UNITED STATES
NUCLEAR REGULATORY COMMISSION
WASHINGTON, D. C. 20555

SUBJECT: INITIAL REVIEW AND RECOMMENDATIONS FOR SITE
SPECIFIC SPECTRA AT SEP SITES

Initial Review and Recommendations for Site Specific
Spectra at SEP Sites

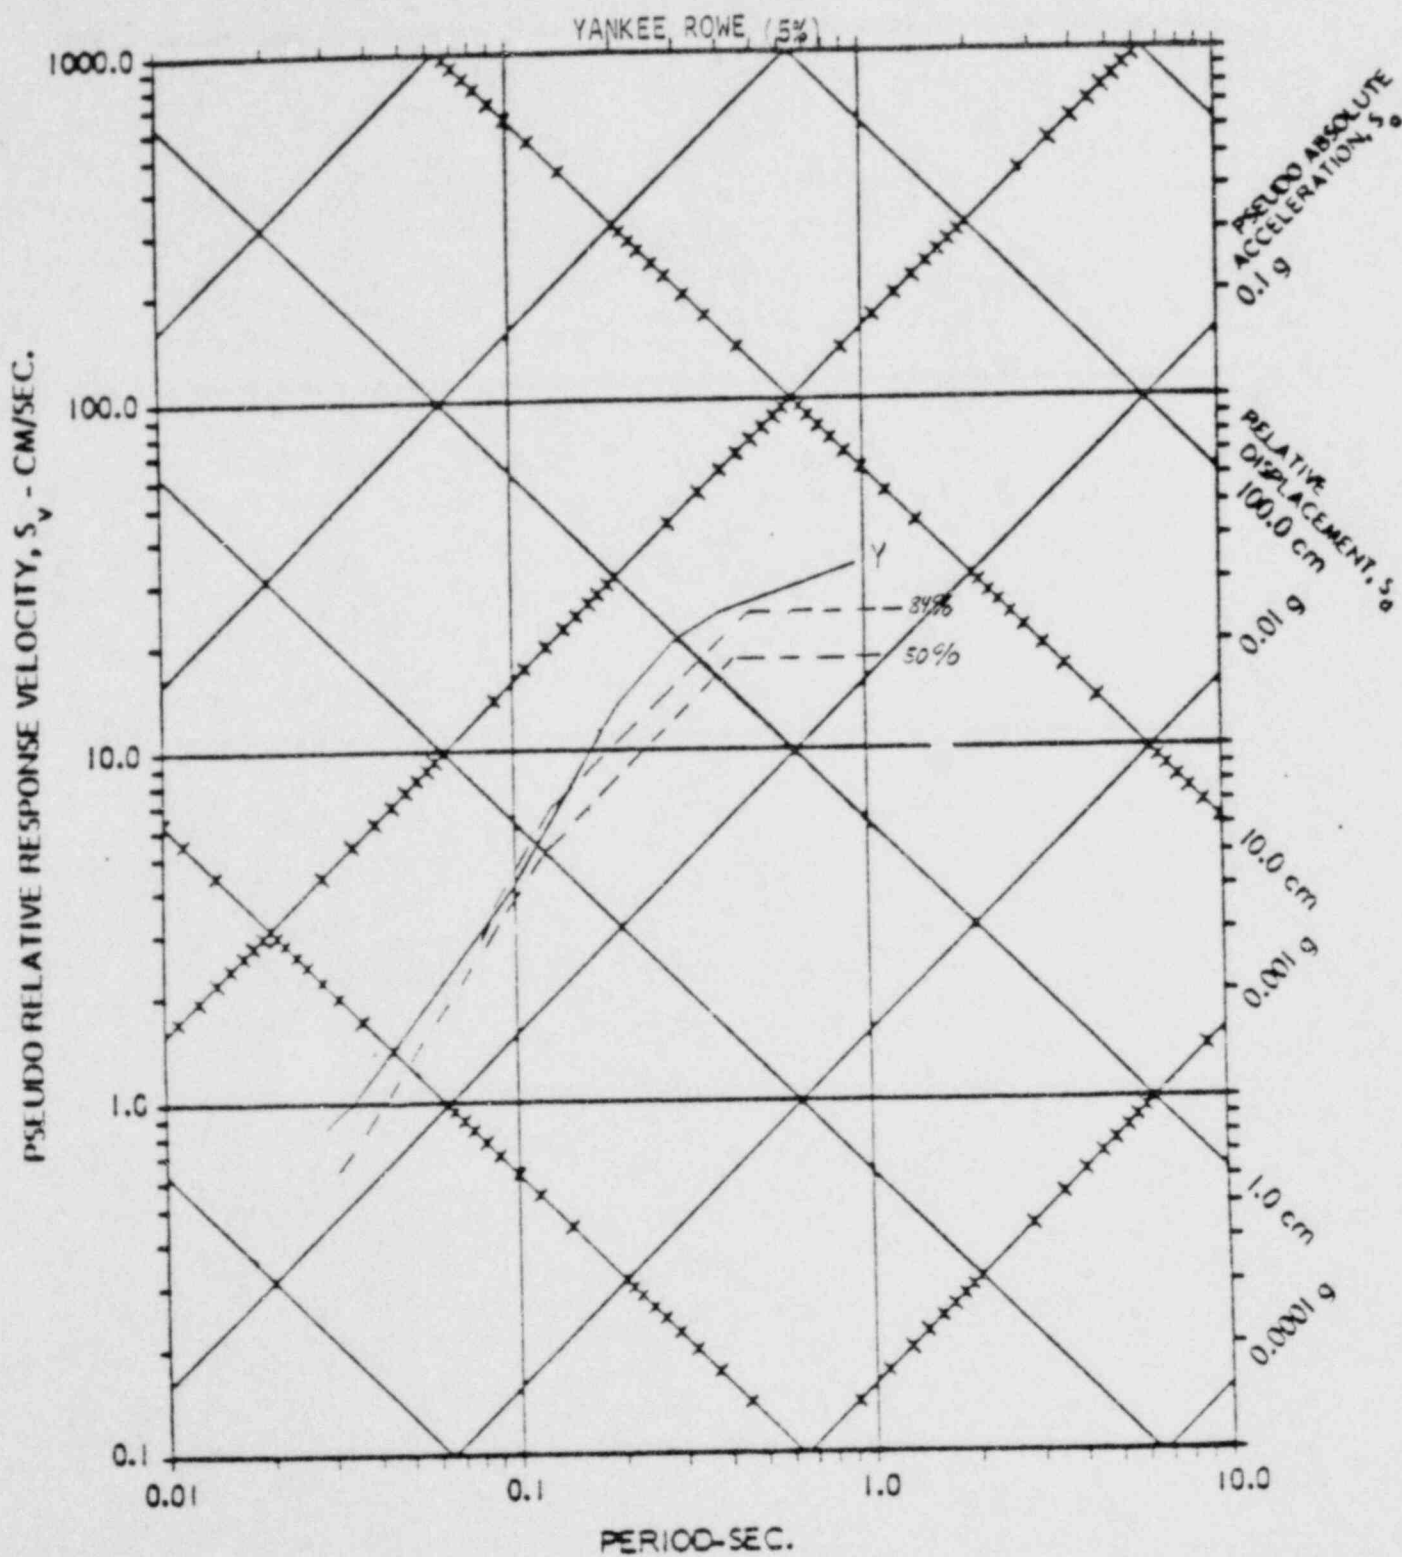
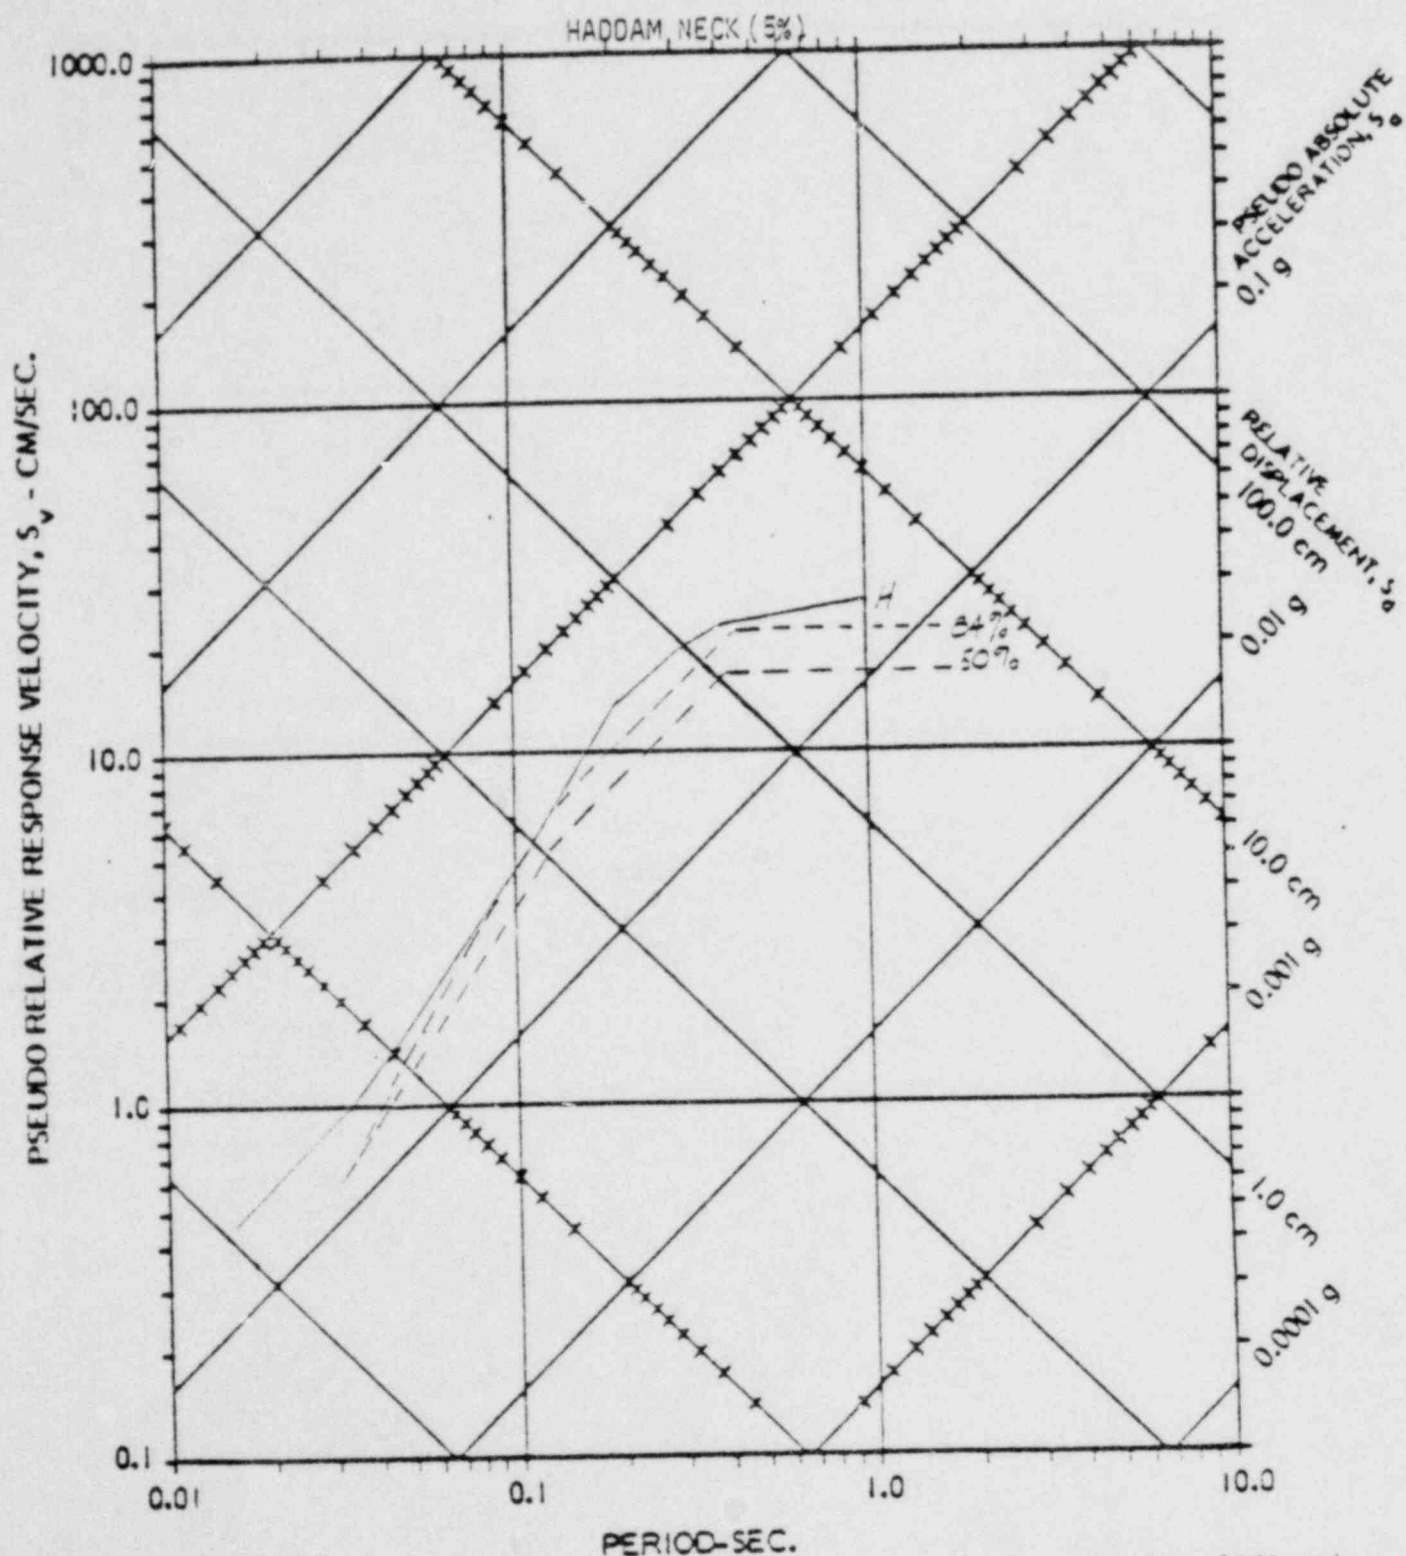
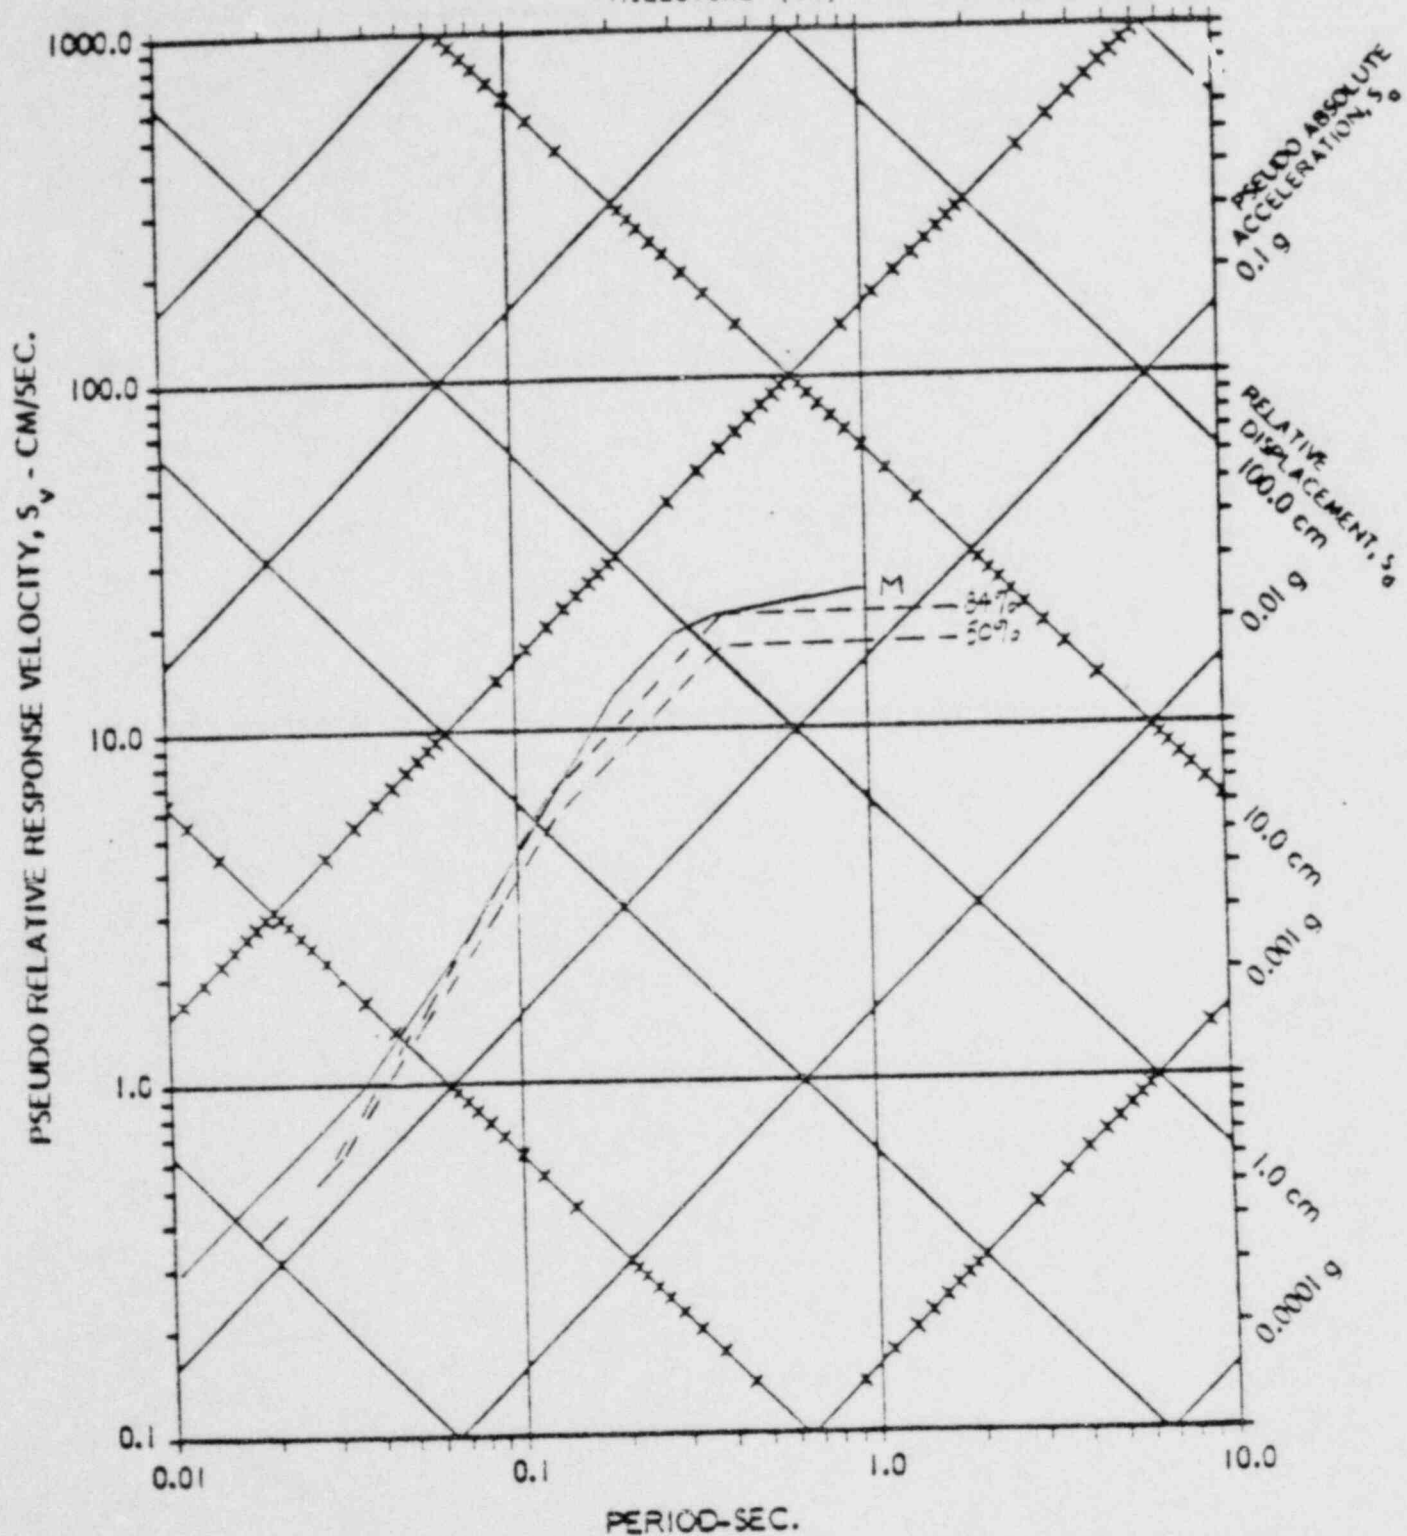
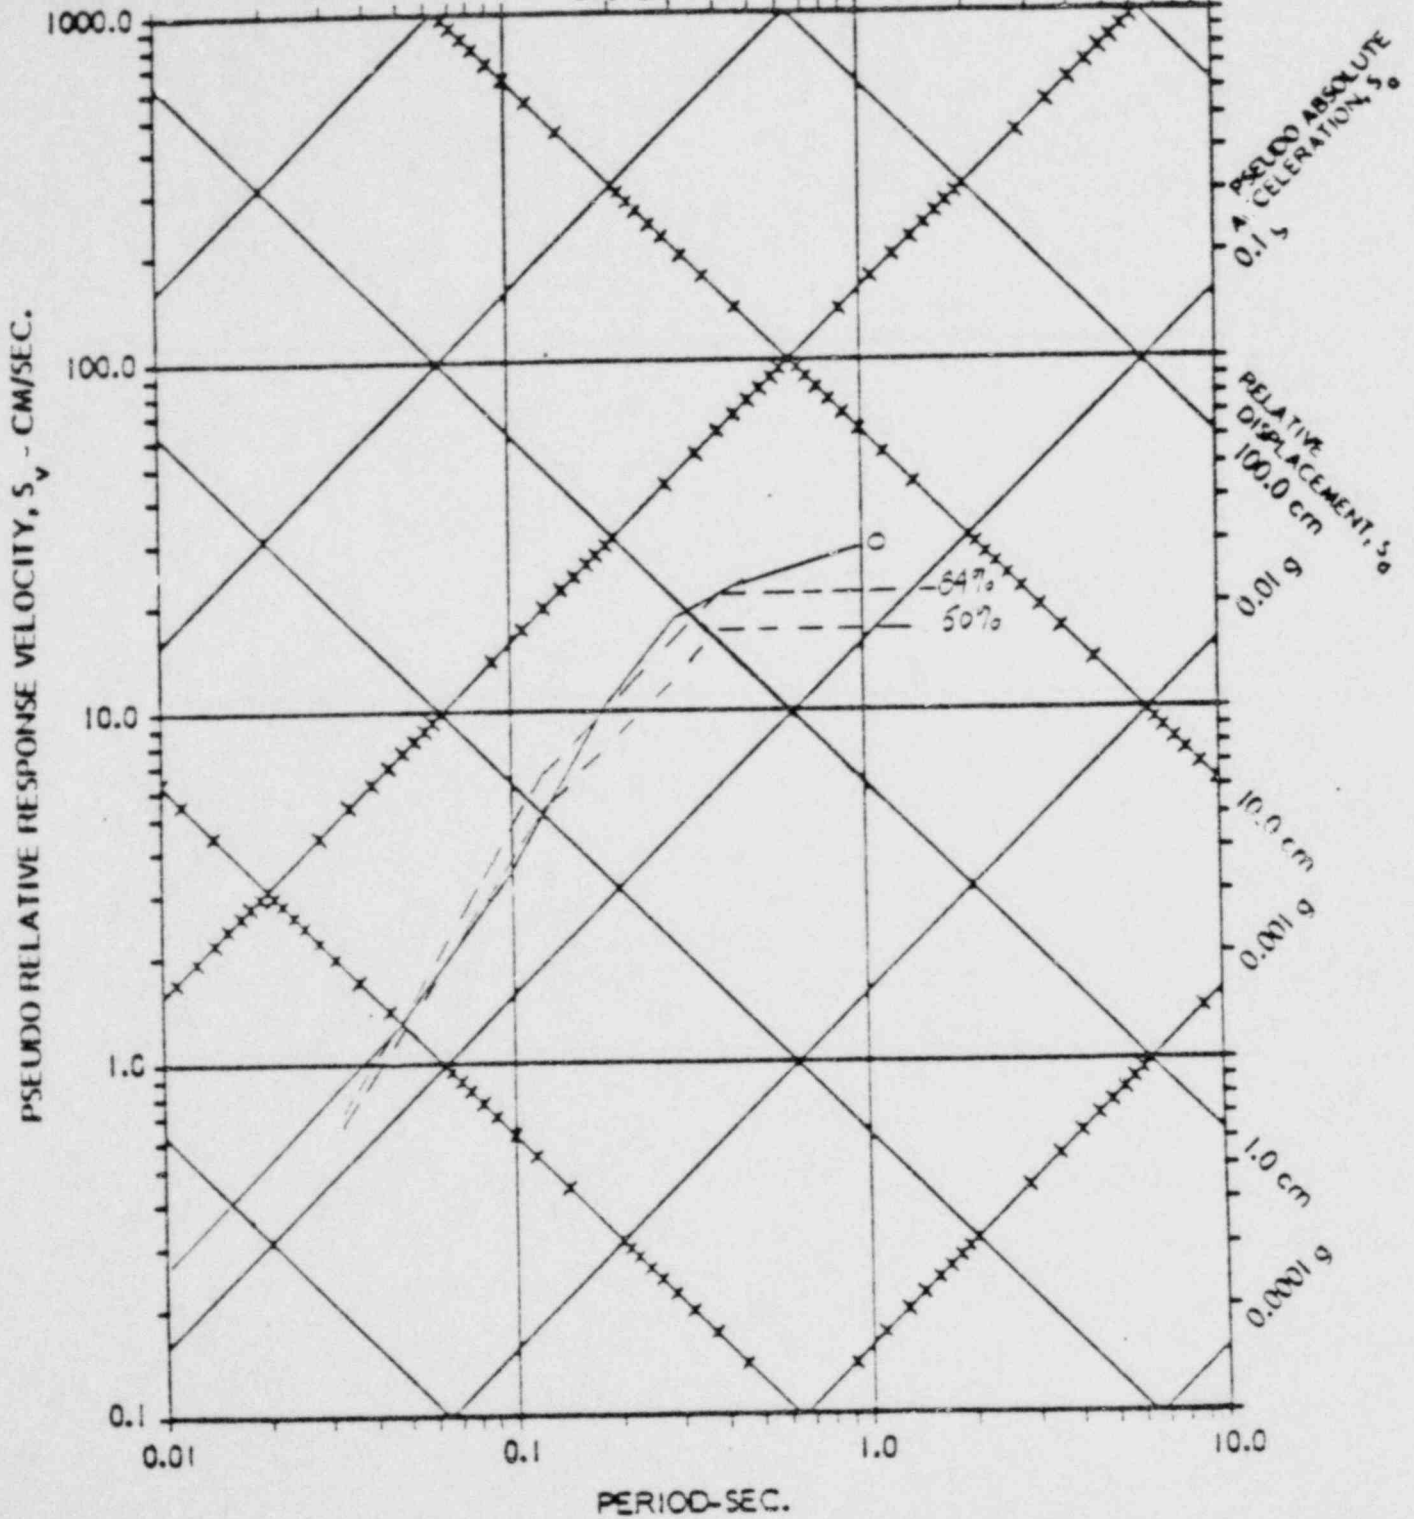
The deterministic peak accelerations and velocities are converted to response spectra using the amplification factors suggested by Newmark and Hall in NUREG CR-0098. Figs. 3 thru 11 compare the recommended uniform hazard spectra with 50th and 84th percentile deterministic spectra. In the central U.S. the recommended spectra generally fall below or at the 50th percentile. In the eastern United States the uniform hazard spectra are approximately

equivalent to the 84th percentile deterministic spectra. While the deterministic peaks are generally lower than the predicted peaks, use of the 84th percentile amplification factors usually more than compensate for the differences. Again the uniform hazard spectra more adequately reflect perceived relative hazard. The "tectonic province" approach can be made to achieve conservatism in this case by utilizing conservative amplification factors.
